**SUBMISSIONS RECEIVED DURING
EXHIBITION OF DRAFT VOLUNTARY
PLANNING AGREEMENT**

1 ALFRED STREET, SYDNEY

RE: Draft Planning Agreement - 1 Alfred St, Circular Quay Sydney between The Council of the City of Sydney and Valad Commercial Management Limited

SK 09
24 April 2012

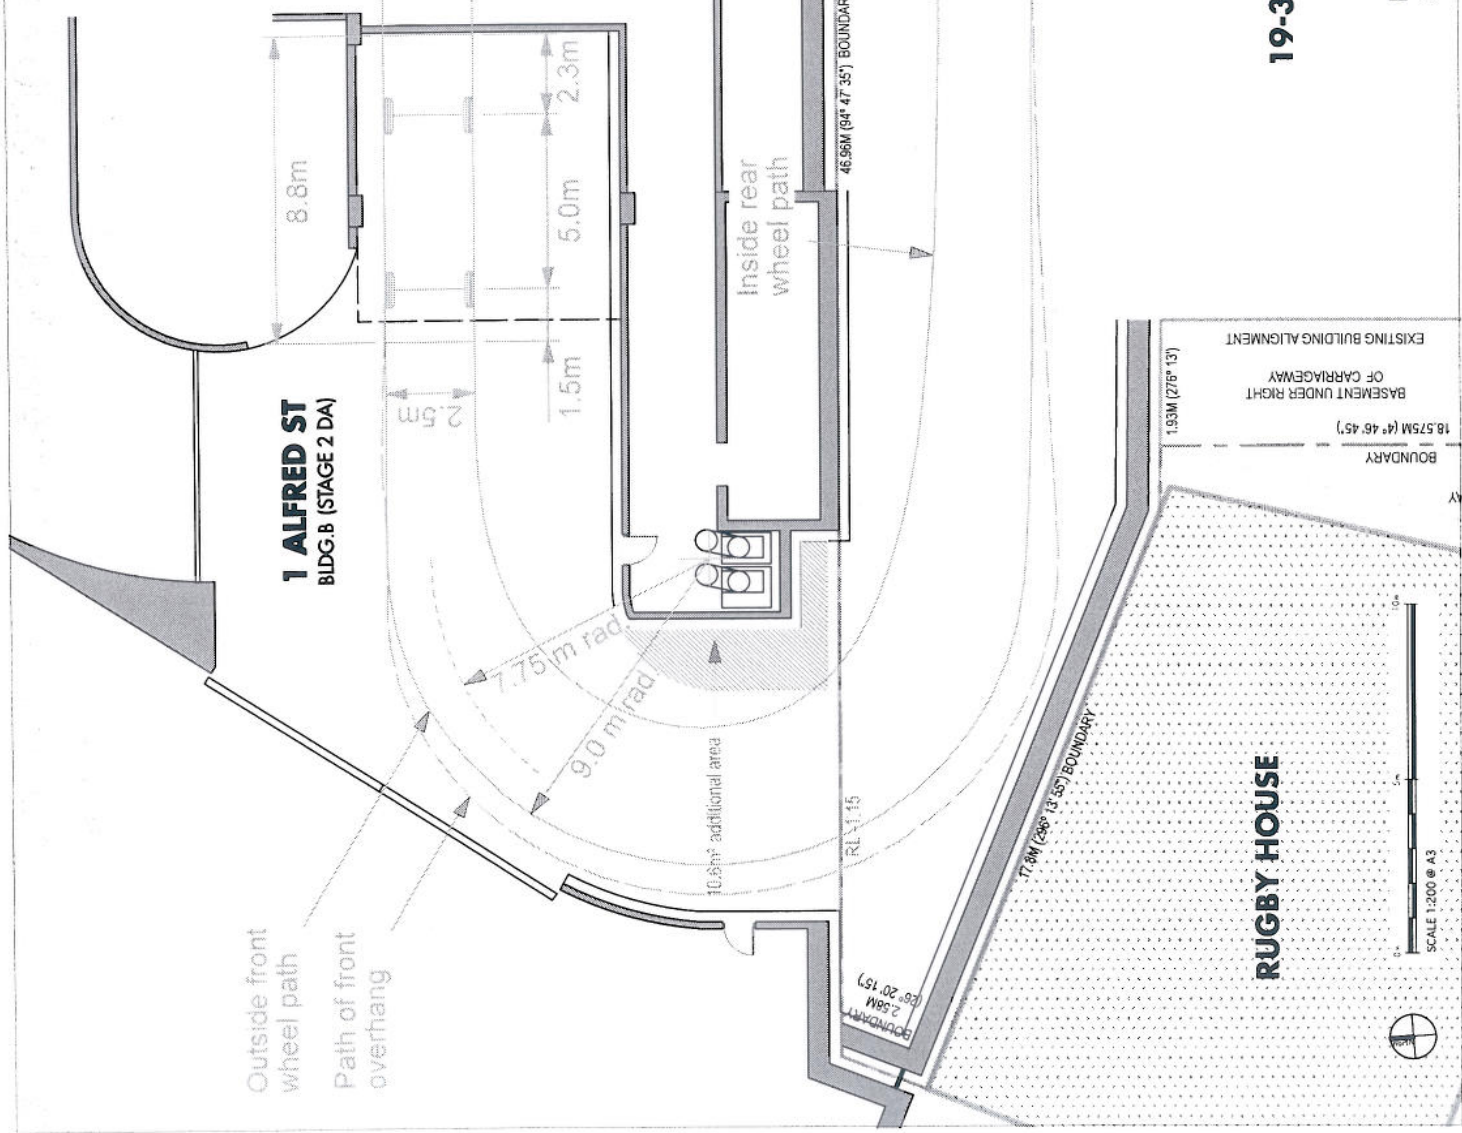
SK09 (8.8m compliant) – Shows the amendment required to the applicants proposal to achieve compliant access for an 8.8m truck. SK10 has been included to note that additional amendments will be required to achieve compliant access for a 12.5m truck.

It is recommended the applicants proposal be amended to the minimum dimensions shown in SK09 to provide compliant access for an 8.8m Vehicle. Of note are the recommended minimum widths, the increased area of the carriageway on the inside radius of the proposed laneway ramp, and the minimum width of the breakthrough. It is suggested further amendments be investigated to provide access for a 12.5m Vehicle.
